NOTE B:
VARIANCE FOR 3'-0" HEIGHT INCREASE SUBJECT
TO THIS APPLICATION (DRB 20-0549). ALL PLANS
AND PROJECT INFORMATION TO REMAIN AS
SUBMITTED IN PLANNING BOARD.

EIGHTEEN SUNSET
1759 PURDY AVE
MIAMI BEACH, FLORIDA
07/16/18

WEST ELEVATION (PURDY) *PROPOSED*

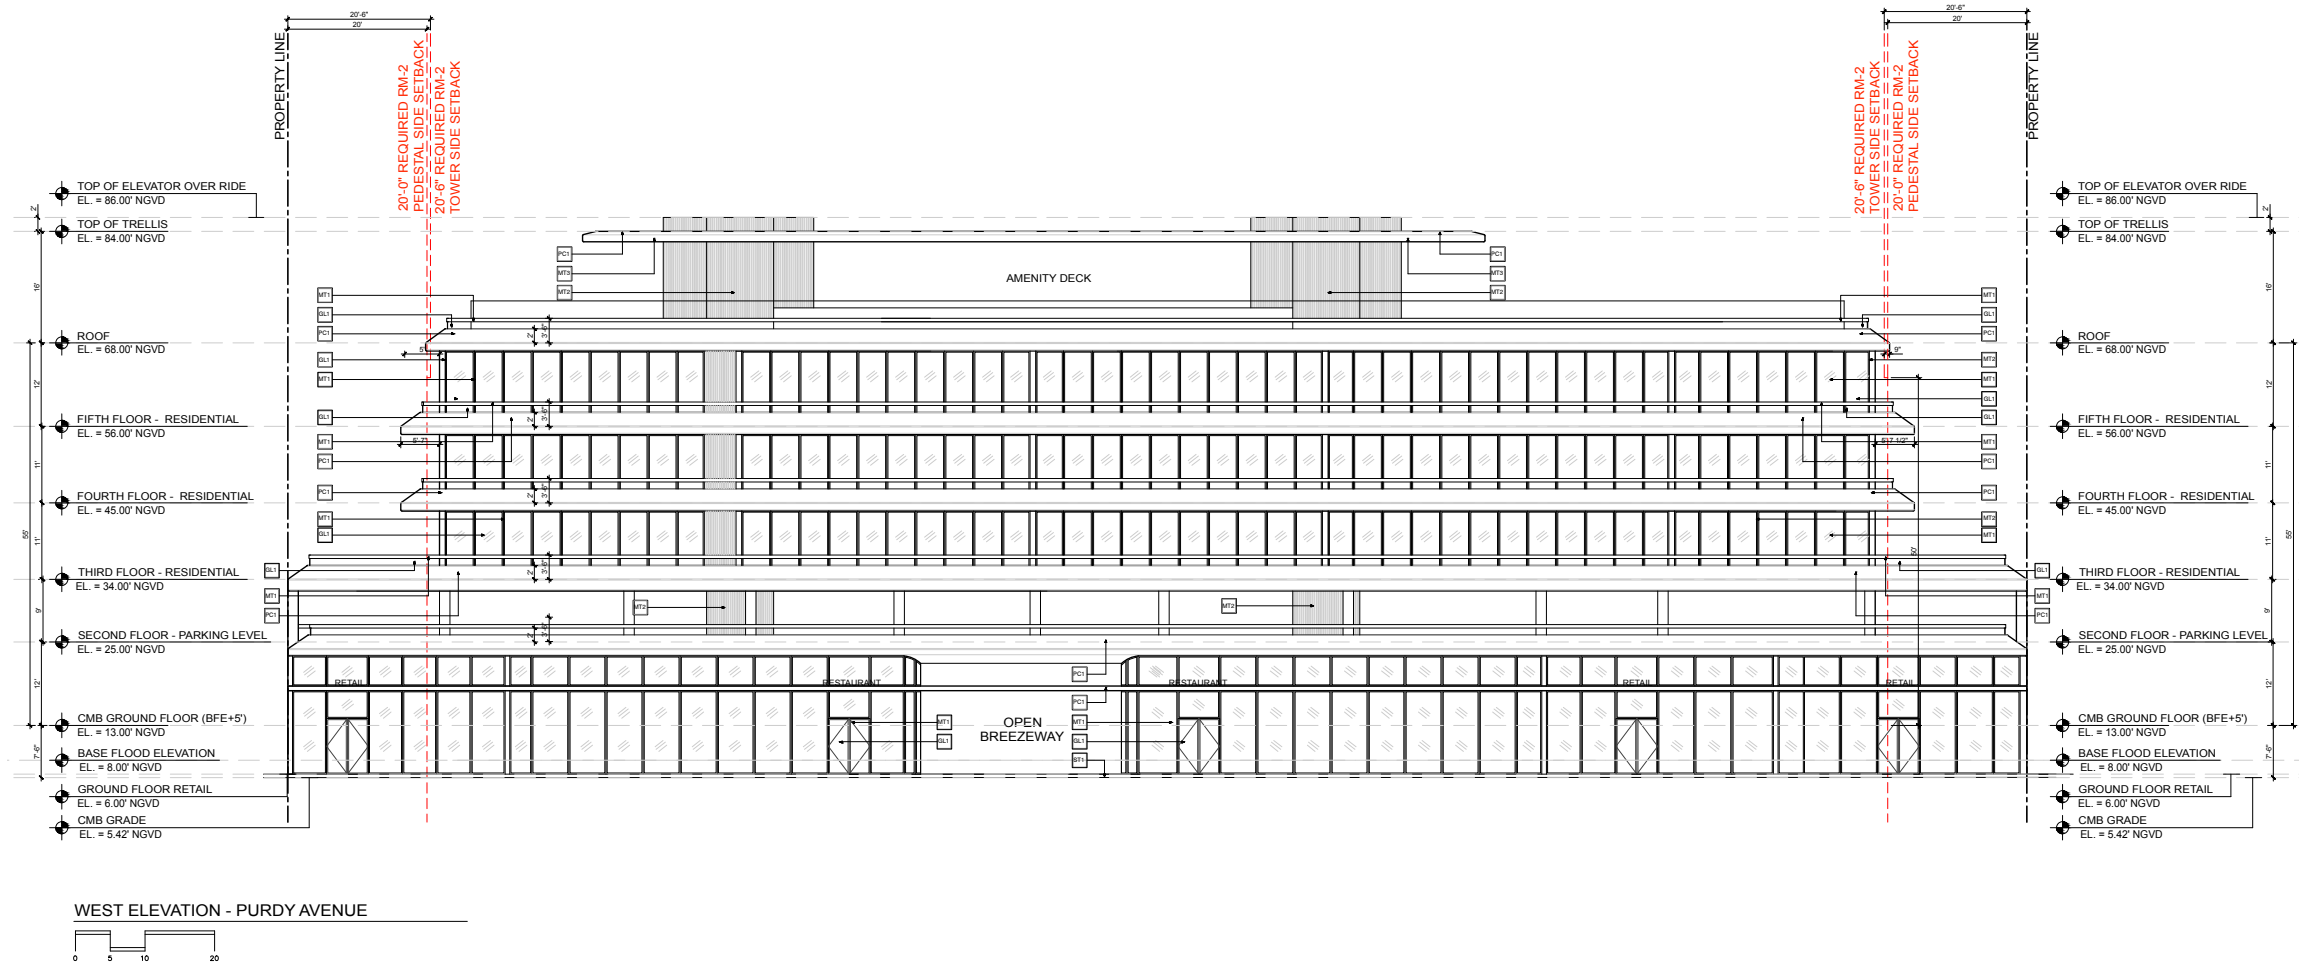
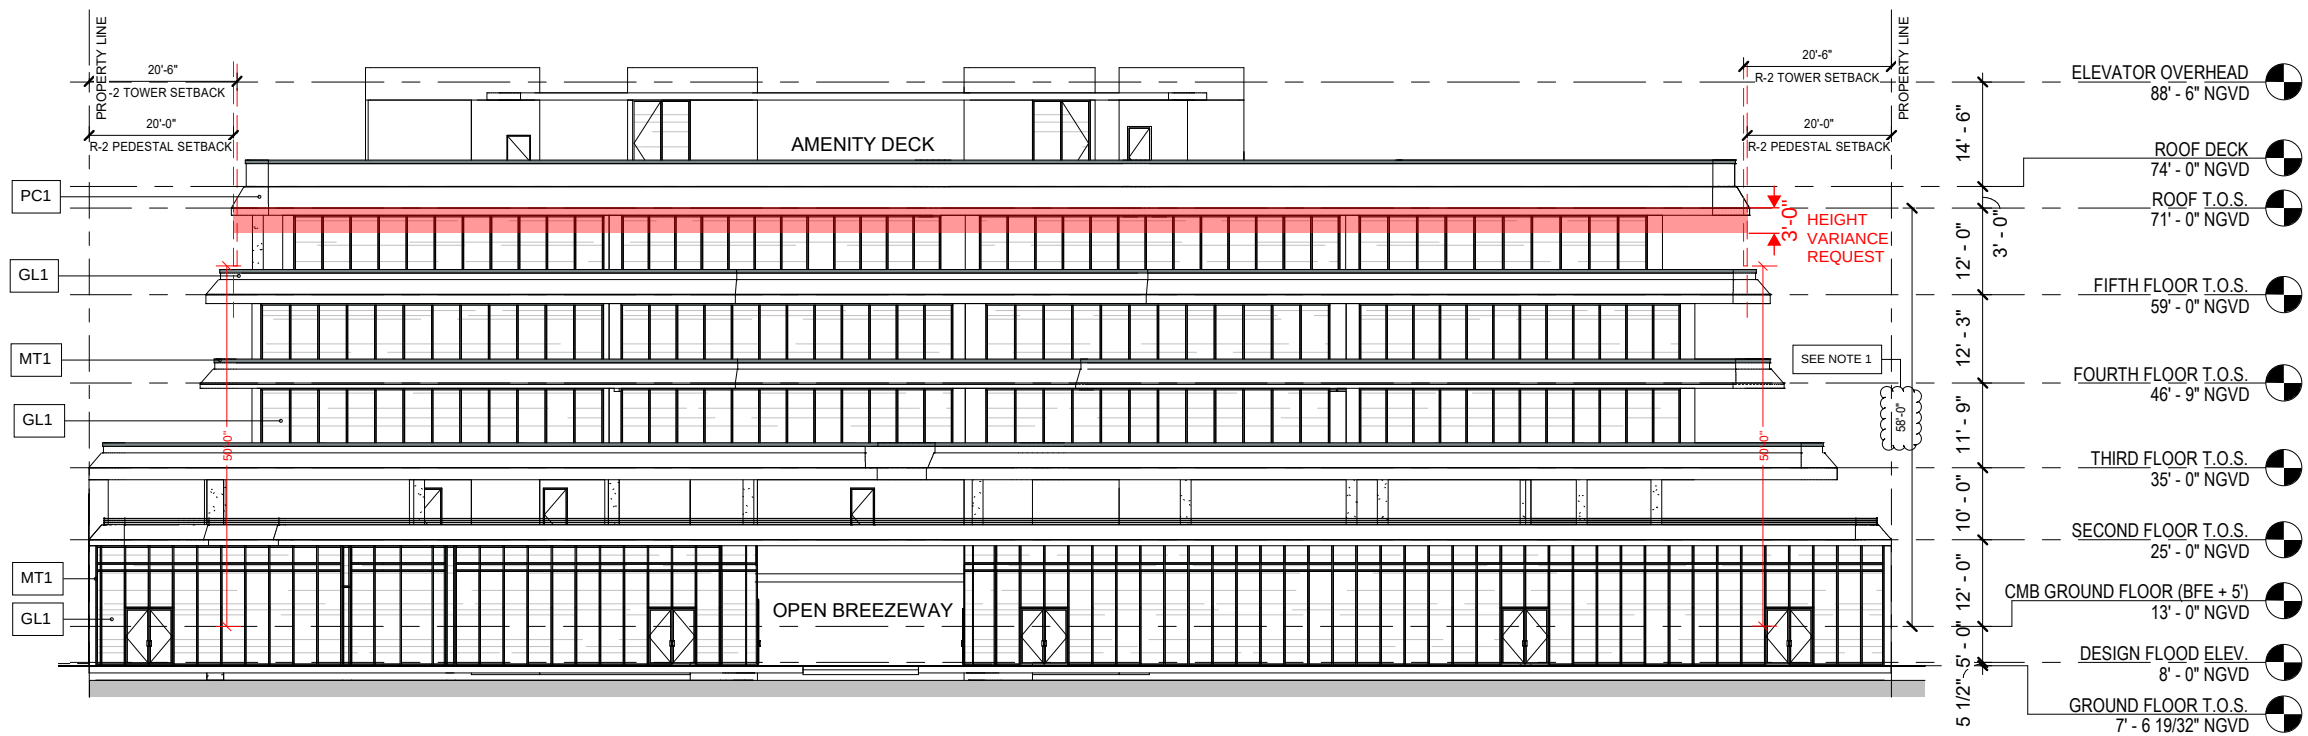
NOTE B:
VARIANCE FOR 3'-0" HEIGHT INCREASE SUBJECT TO THIS APPLICATION (DRB 20-0549). ALL PLANS AND PROJECT INFORMATION TO REMAIN AS SUBMITTED IN PLANNING BOARD.

EAST ELEVATION (BAY) *PROPOSED*

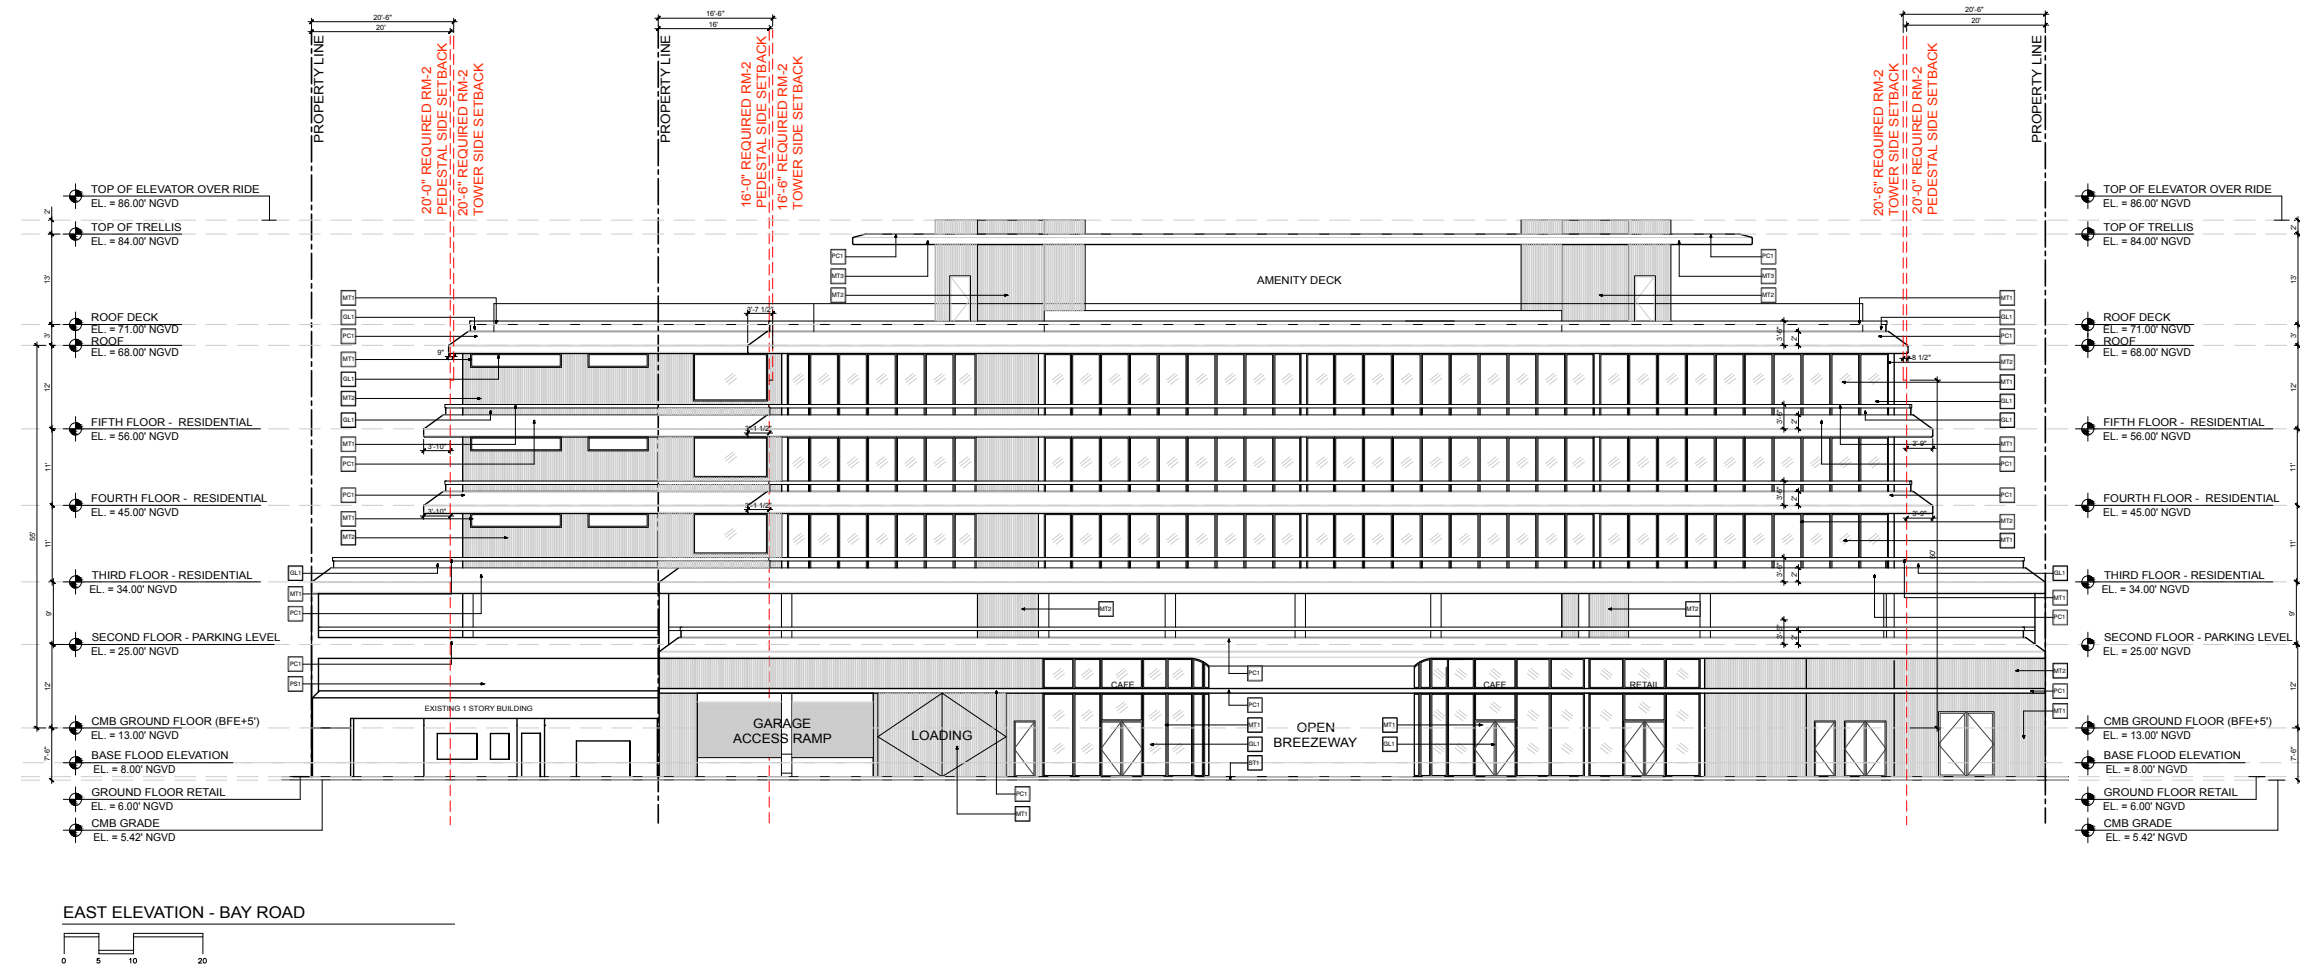
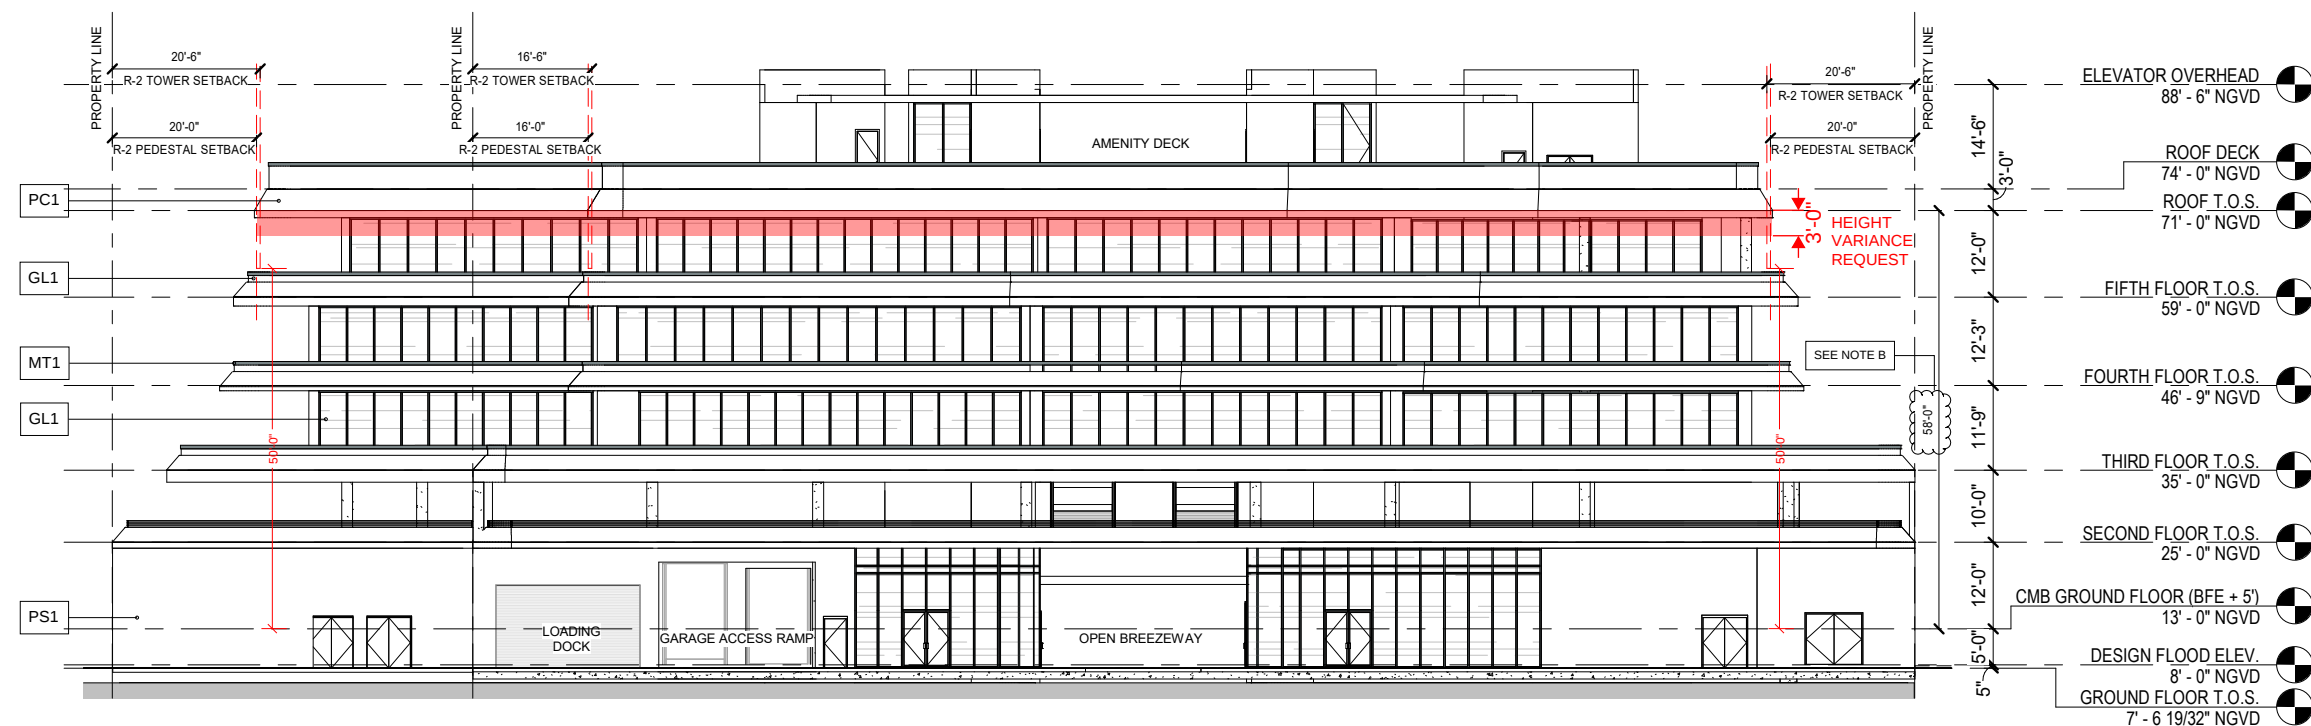
NOTE B:
VARIANCE FOR 3'-0" HEIGHT INCREASE SUBJECT TO THIS APPLICATION (DRB 20-0549). ALL PLANS AND PROJECT INFORMATION TO REMAIN AS SUBMITTED IN PLANNING BOARD.

NORTH ELEVATION *PROPOSED*

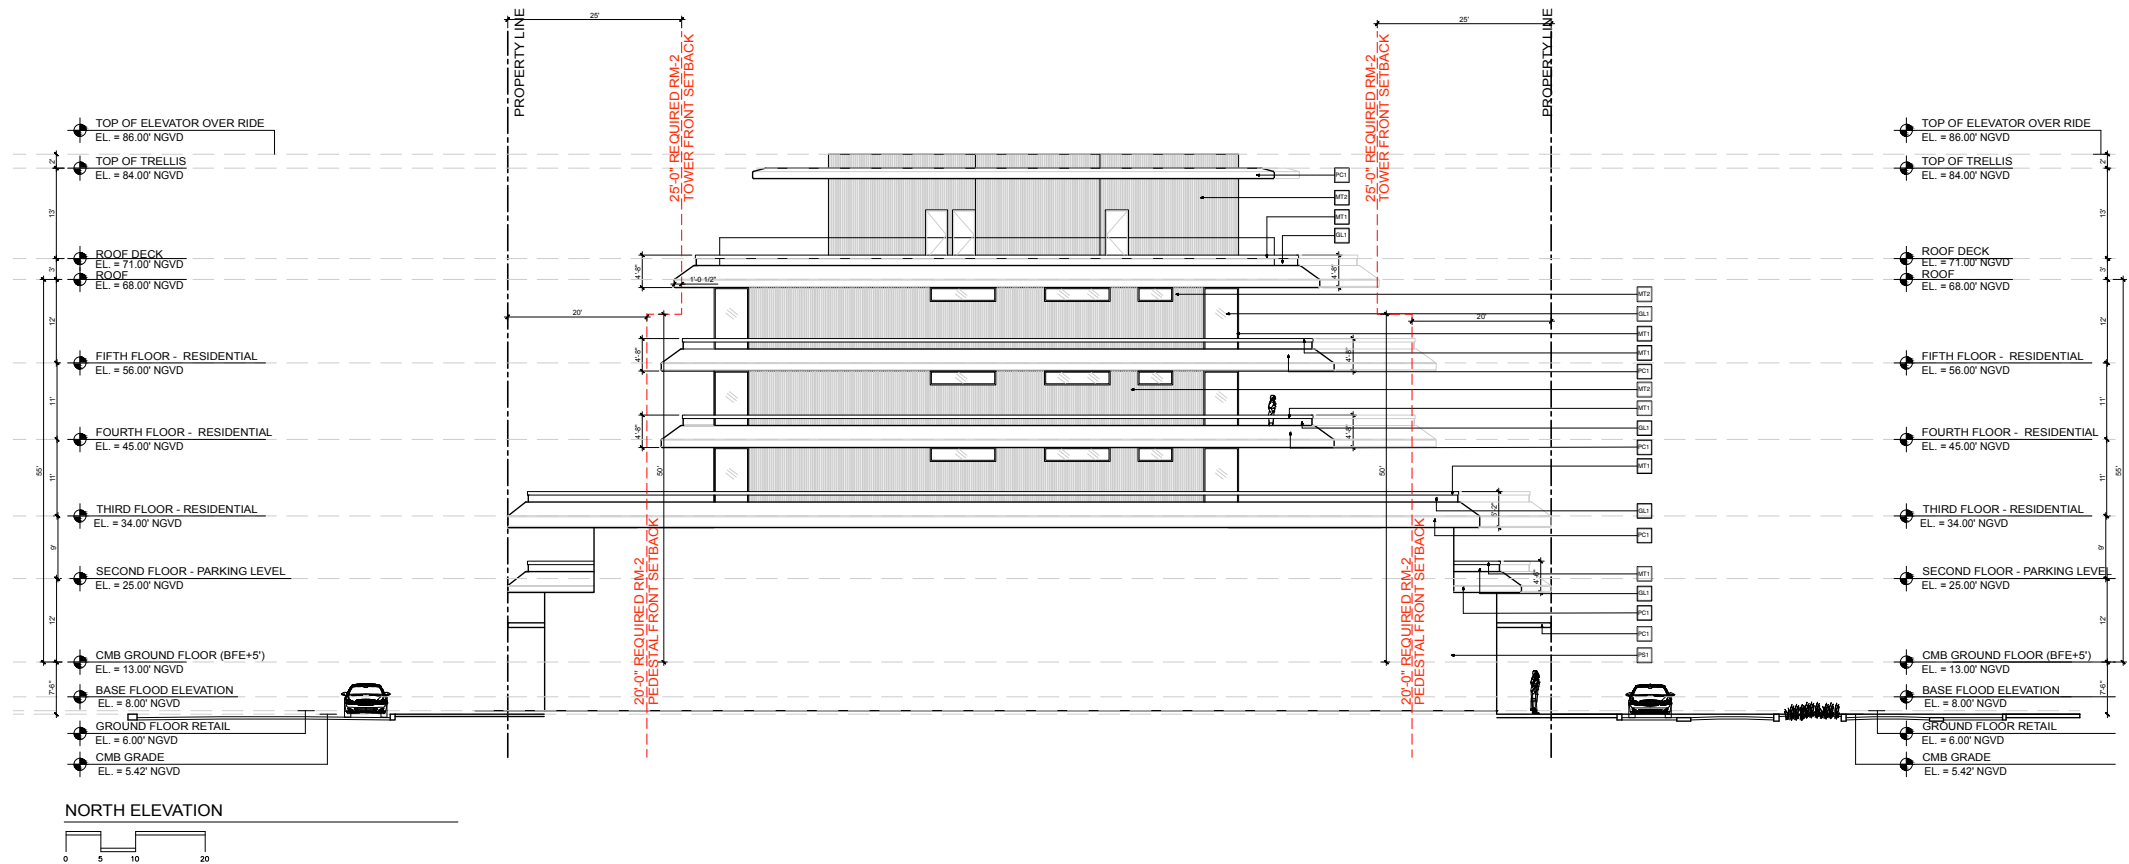
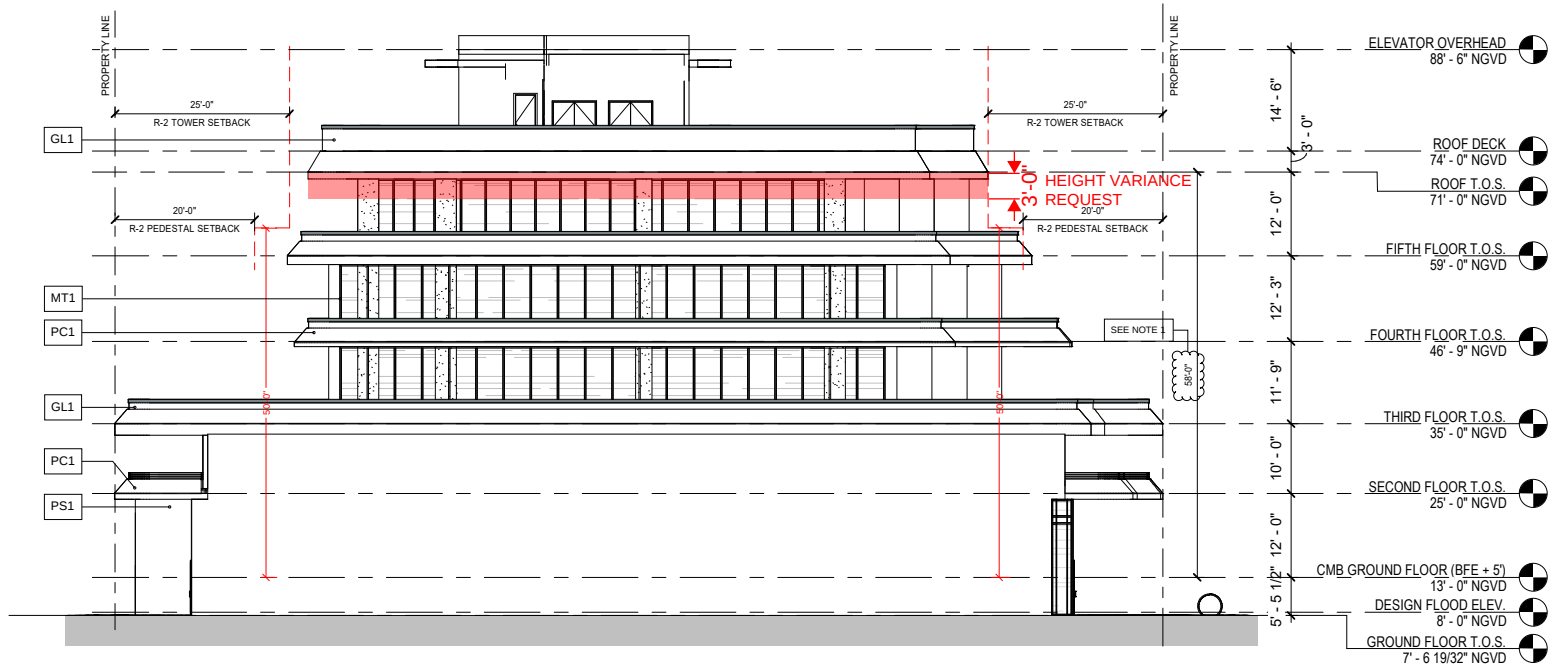
NOTE B:
VARIANCE FOR 3'-0" HEIGHT INCREASE SUBJECT TO THIS APPLICATION (DRB 20-0549). ALL PLANS AND PROJECT INFORMATION TO REMAIN AS SUBMITTED IN PLANNING BOARD.
